19 February 2016

RE: Arboricultural Assessment of Supporting Removal of Tree 5 Camphor Laurel: MP10_0016 - "The Terraces" 2 Cooper Street, Paddington
Ref: 246MonTree5[AR-RE-P-1007]

Attachment D: Site Establishment - Stage 1 (PM-P-2002, Rev 3)

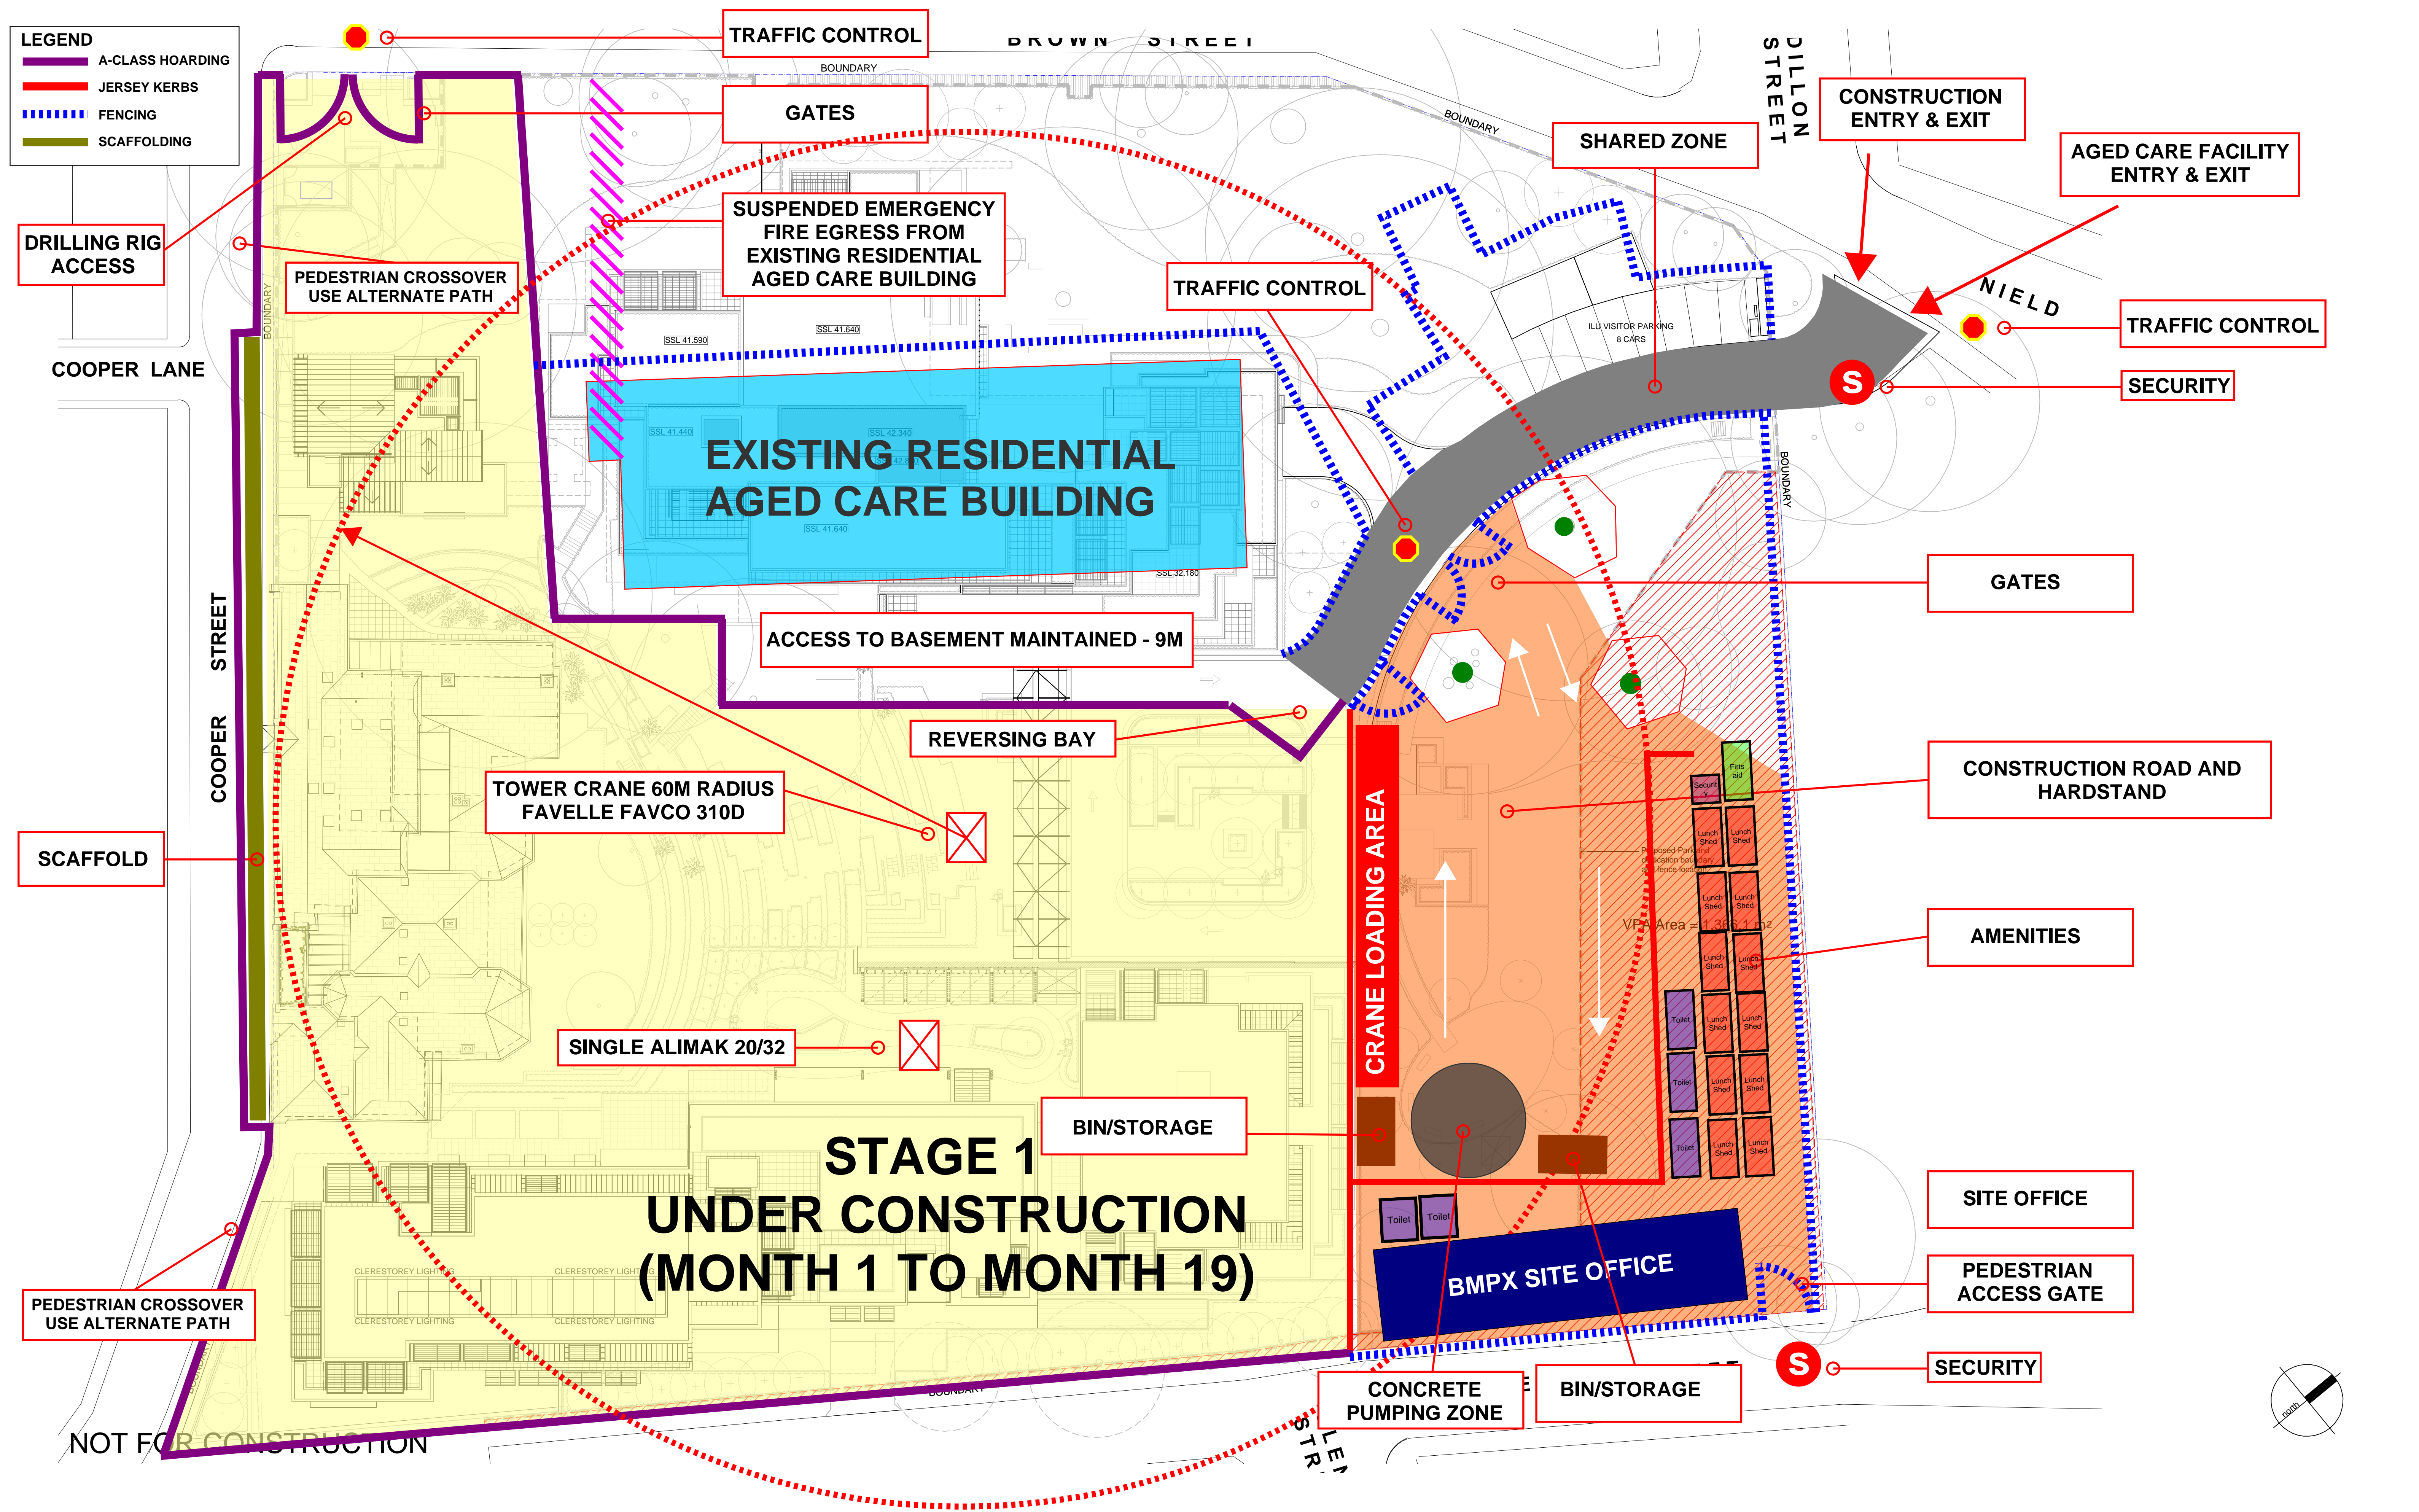
A temporary construction Driveway has recently been built to the Project Arborist's (TWM) specifications for the purposes of Stage 1 construction (Photo D). This temporary Driveway passes between Tree 5 and Tree 6. The alignment of the Driveway is as indicated on *Site Establishment Plan – Stage 1, PM-P-2002 Rev. 3* prepared by BMC (Attachment C).

- It will provide a better Stage 1 hardstand layout benefiting Heritage Listed Tree 6. Trucks and vehicles will not need to exist the gate south of Tree 6 indicated on *PM-P-2002, Rev 3*. This temporary Driveway south of Tree 6 has not yet been constructed.

Attachment E: Site Establishment - Stage 1 (PM-P-2002, Rev 4) with T5 removed

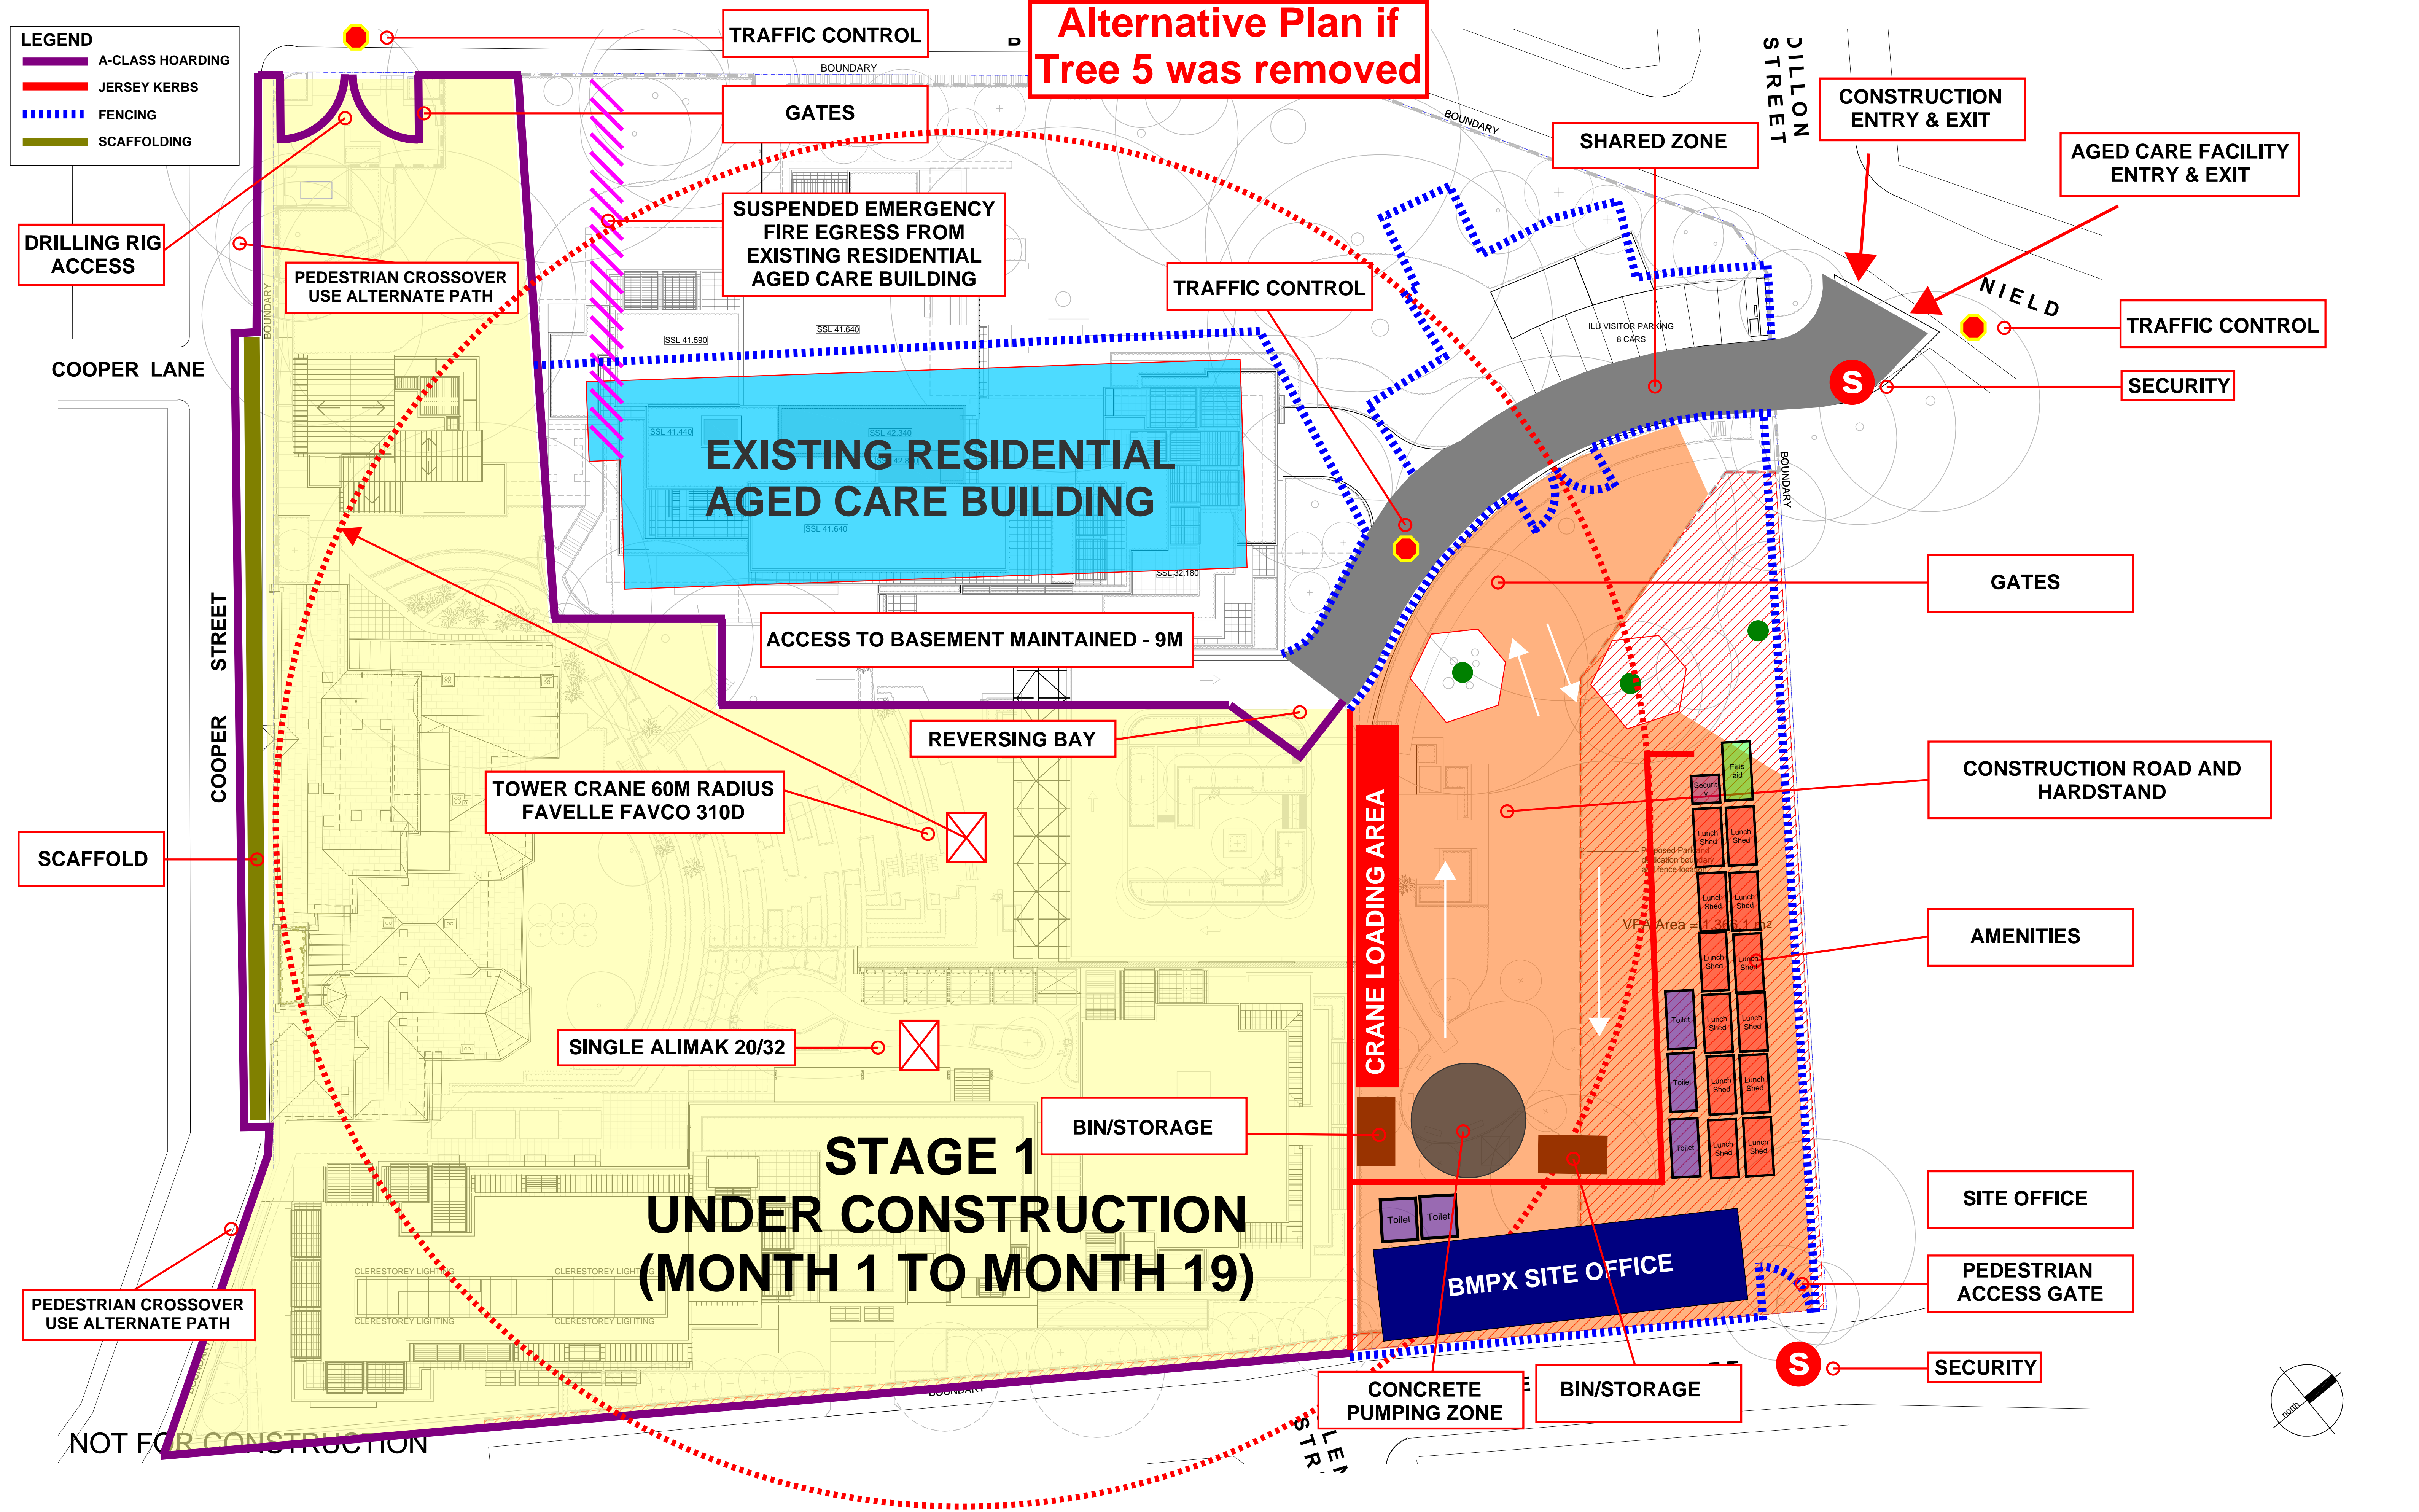
The Stage 1 works have commenced and temporary Driveway is in place for works between Trees 5 and Tree 6. The *Site Establishment – Stage 1 PM-P-2002, Rev 4* (Attachment E) shows the revised hardstand Driveway and gate layout with Tree 5 removed.

Attachment G: Site Establishment - Stage 2 (PM-P 2003, Rev 4) with T5 removed

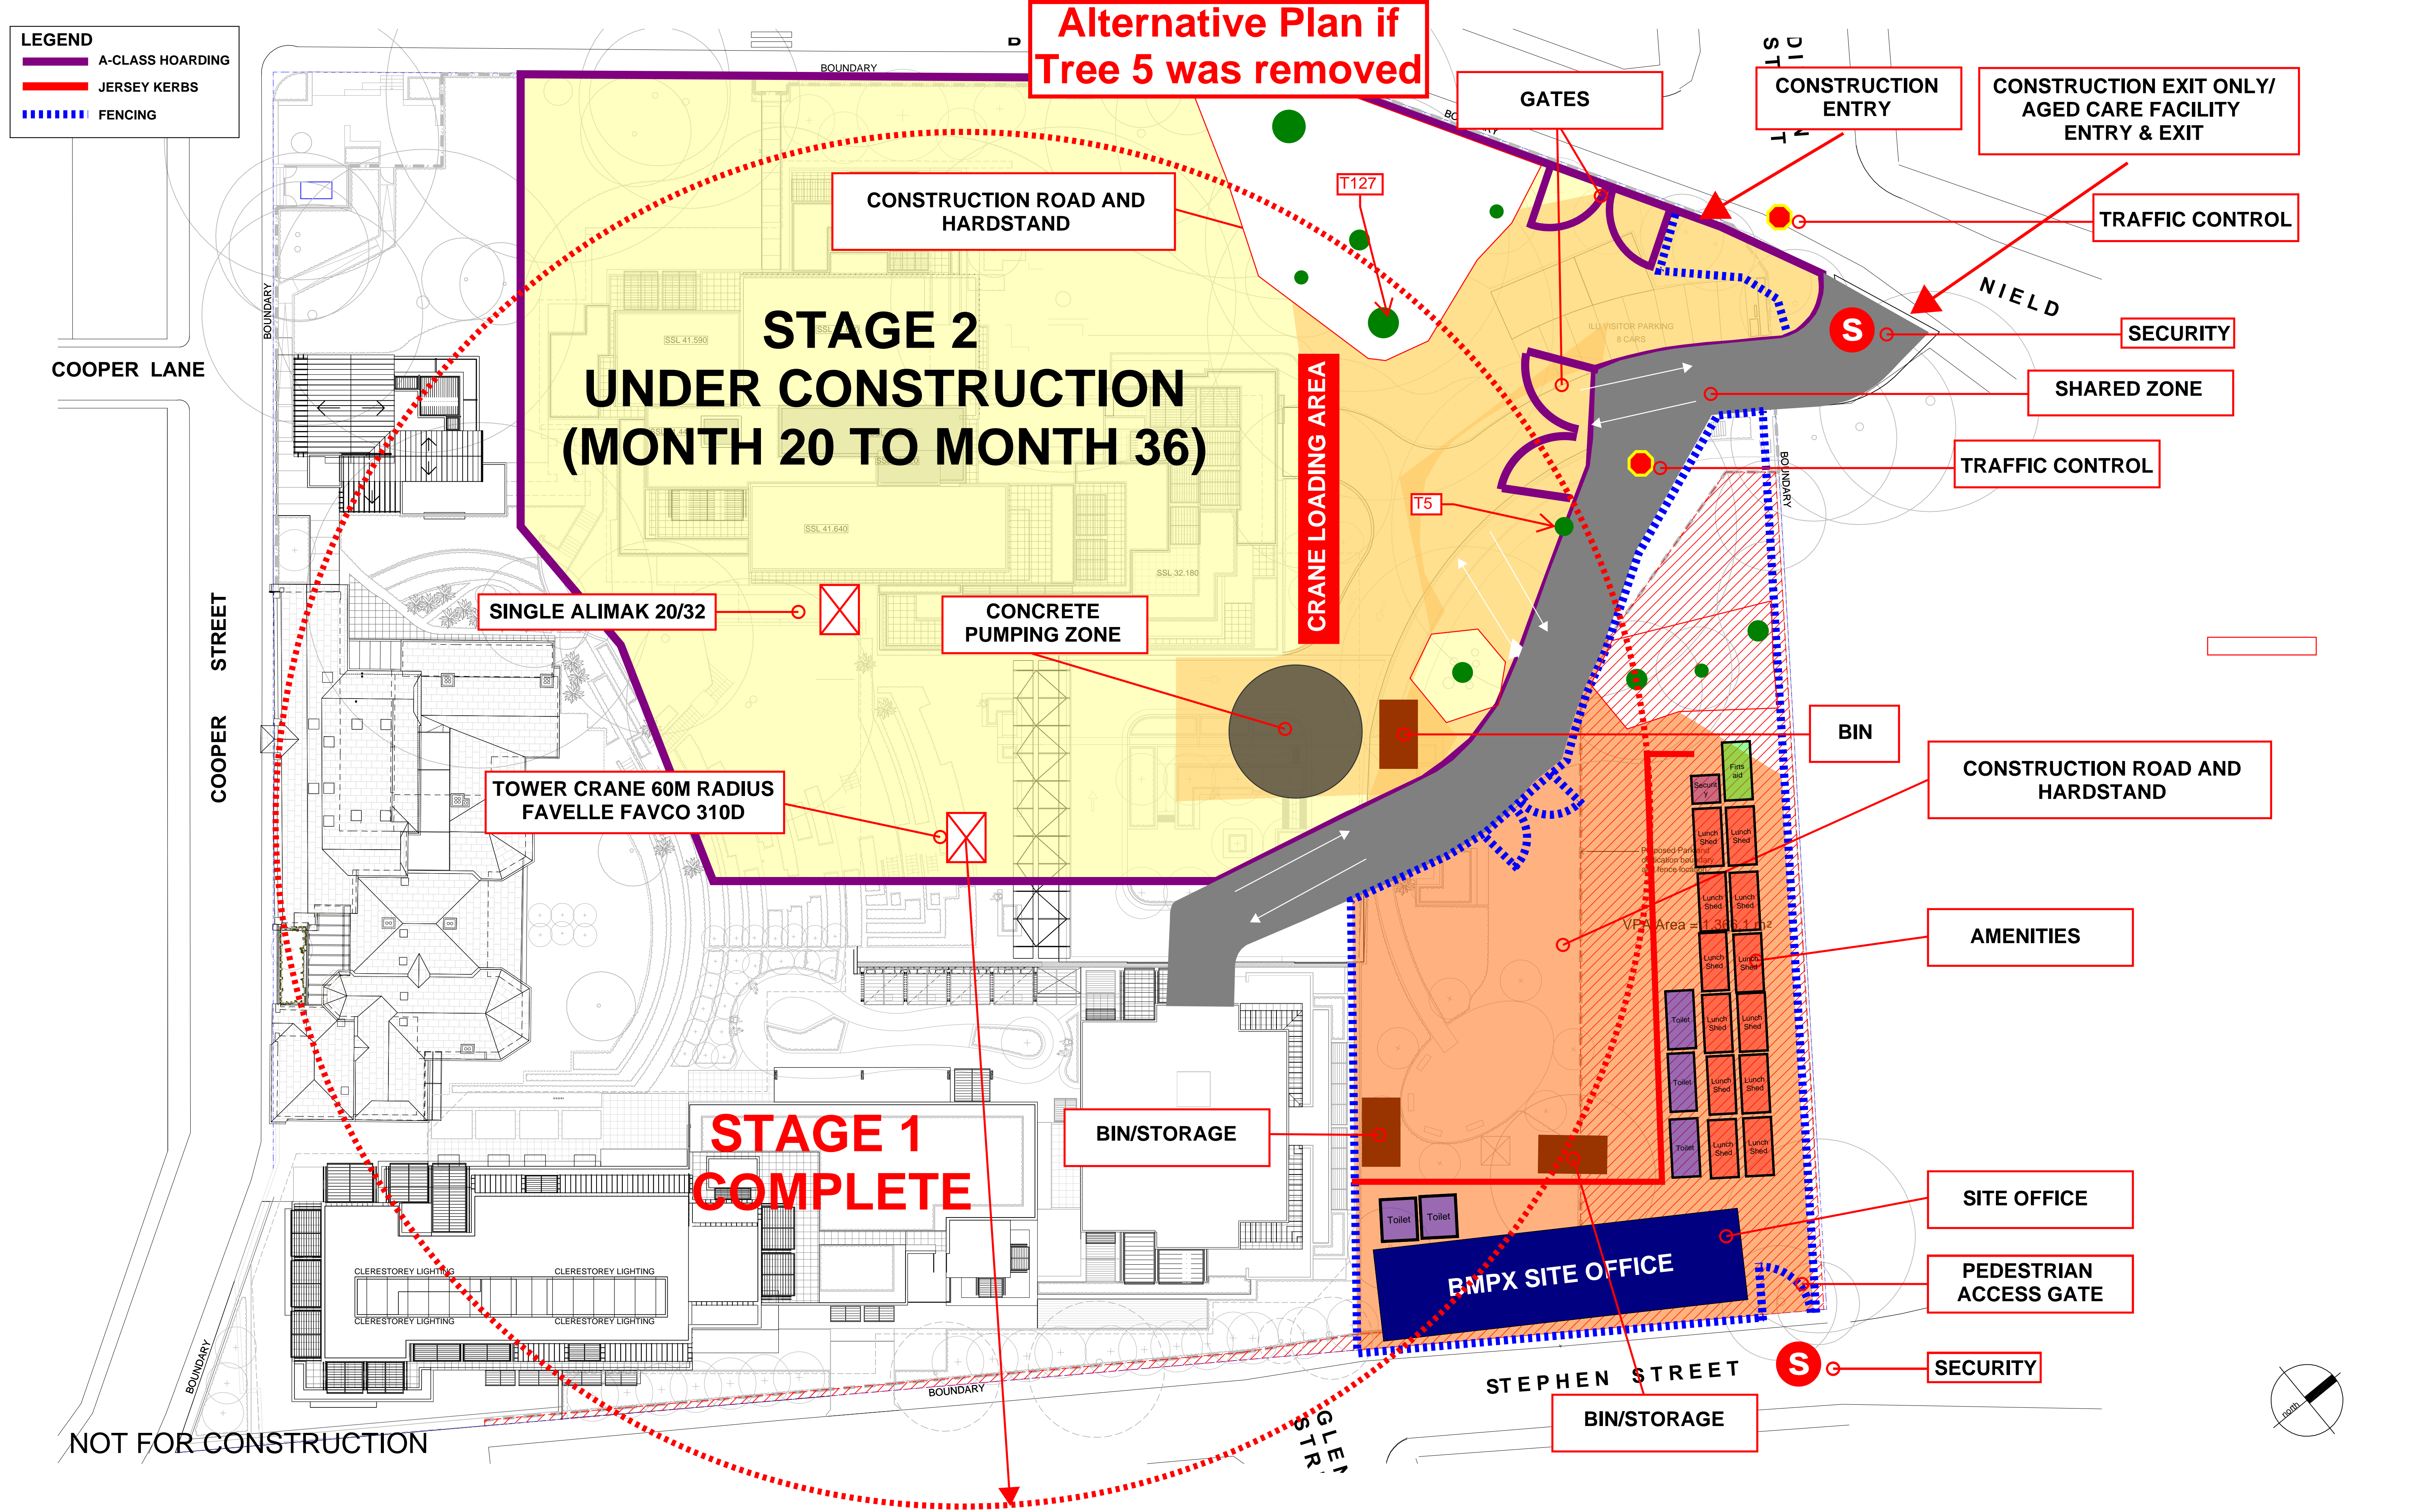
A revised *Site Establishment – Stage 2, Rev 4* (Attachment G) has been prepared with Tree 5 removed. This changes the alignment of the vehicular access road and it shifts the construction zone away from Trees 6, 122, 126, 127 and 133.
